***Memo from Ann Burroughs for Kay Greeley, Landscape
Tree Consultant regarding 05-CUP-006 and -05-OTP-032
– Sunbelt Enterprises. June 1, 2009.***

To: Valerie Darbouze, City of Agoura Hills
From: Ann Burroughs for Kay Greeley, Landscape and Oak Tree Consultant
Date: June 1, 2009
Re: 05-CUP-006 and 05-OTP-032 – Sunbelt Enterprises

***Geotechnical Engineering and Geologic Study,
(Planning Case No. 05-CUP-006 & 05-OTP-32/GDI No.
05.00103.0136) Proposed Two Office Buildings, 29515
Canwood Street, Agoura Hills, California. Advanced
Geotechnical Services, Inc. May 14, 2004. (Note: two
plates provided as independent files)***

Slope Setbacks	
Based on Uniform Building Code 1997 Edition Section 1806.5	
Client Number	3315
Report Number	6583
Figure	2

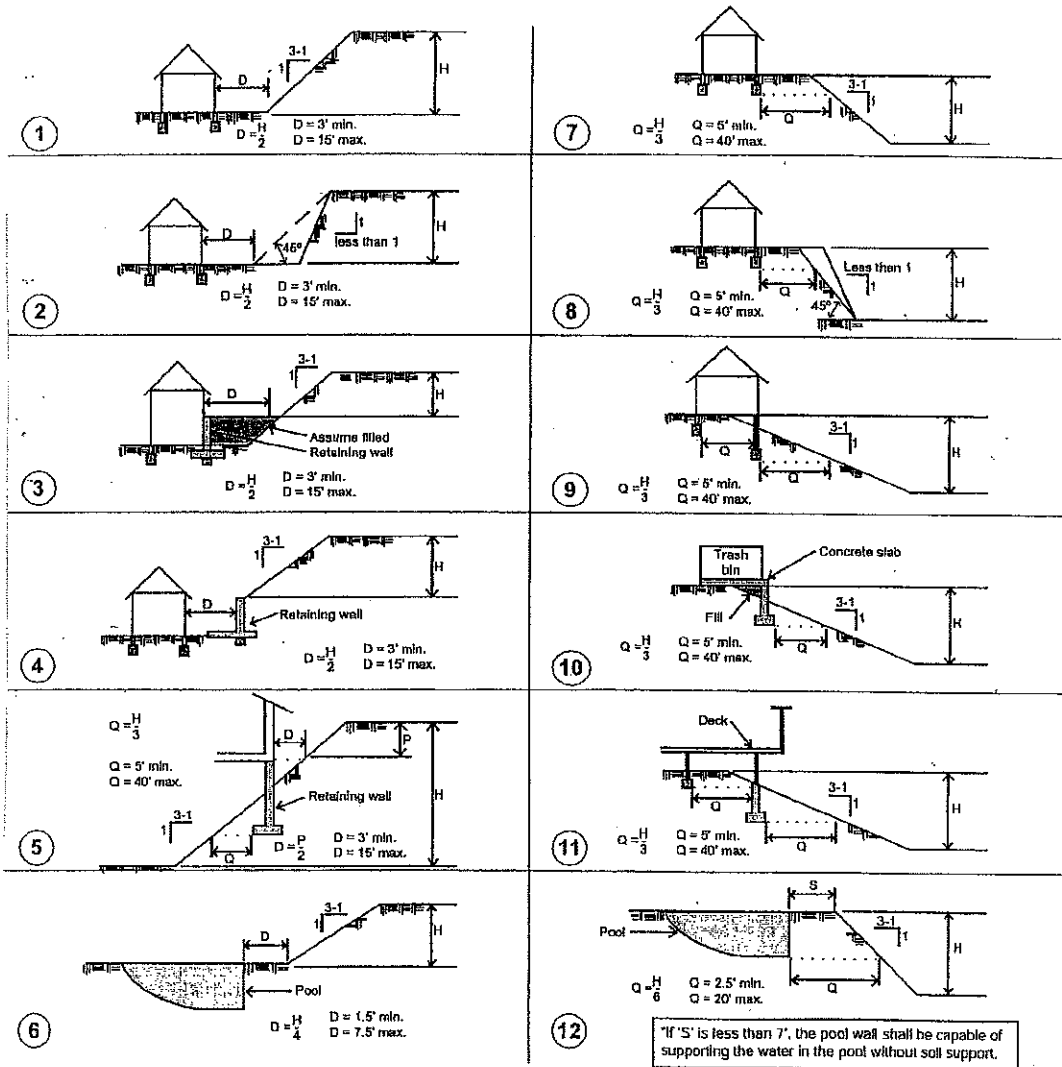
Although the specific setbacks proposed appear to be in compliance, the generic setback recommendations provided on Page 9, 16 and Figure 2 do not appear to comply with the City of Agoura Hills Building Code. The consultant should revise setback recommendations to comply with the City of Agoura Hills Building Code requirements.

2. Although the specific setbacks proposed appear to be in compliance, the generic setback recommendations provided on Page 9, 15 and Figure 2 do not appear to comply with the City of Agoura Hills Building Code. The consultant should revise setback recommendations to comply with the City of Agoura Hills Building Code requirements.

When located next to a descending 3(H):1(V) slope or steeper, the base of the foundation should be a minimum of 5 feet or one-half the slope height from the face of slope, whichever is greater, but need not exceed 40 feet from the face of slope. Examples of foundation setback requirements have been revised and are included in Figure 3.
